**Ref.: Regulation No. 48
Draft Amendment on AFS**

6th GRE-AFS Informal meeting
17-19 February 2004

Proposal by GTB-AFS

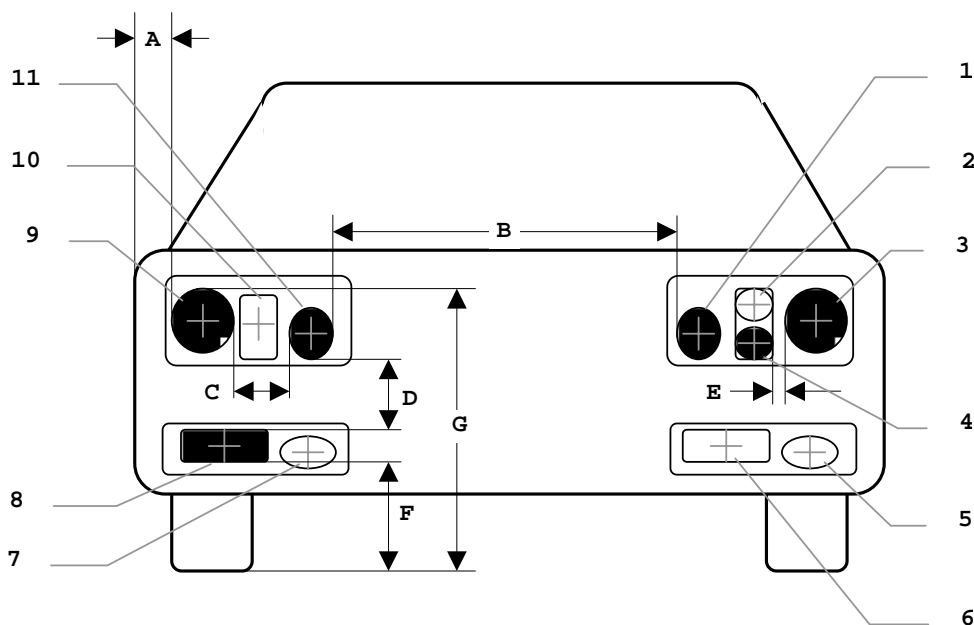
GTB-AFS, from wp 5-11: for clarification, relative to 6.20.4.1.4. amendment

6.20.4.1.2. *Additional lighting units, if any, on either side of the vehicle shall be positioned at a distance not exceeding 140 mm 7/ in horizontal direction (E in the figure) and 400 mm in vertical direction above or below (D in the figure) from the nearest lighting unit;*

None of the additional lighting units described in paragraph 6.20.4.1.2. above shall be positioned lower than 250 mm (F in the figure) nor higher than 1200 mm (G in the figure) above the ground;

the outer edge of the apparent surface of at least one lighting unit on each side of the vehicle shall not be more than 400 mm from the extreme outer edge of the vehicle (A in the figure); and,

the inner edges of the apparent surfaces in the direction of the reference axes shall be not less than 600 mm apart. This does not apply, however, for M₁ and N₁ category vehicles; for all other categories of motor vehicles this distance may be reduced to 400 mm where the overall width of the vehicle is less than 1300 mm."
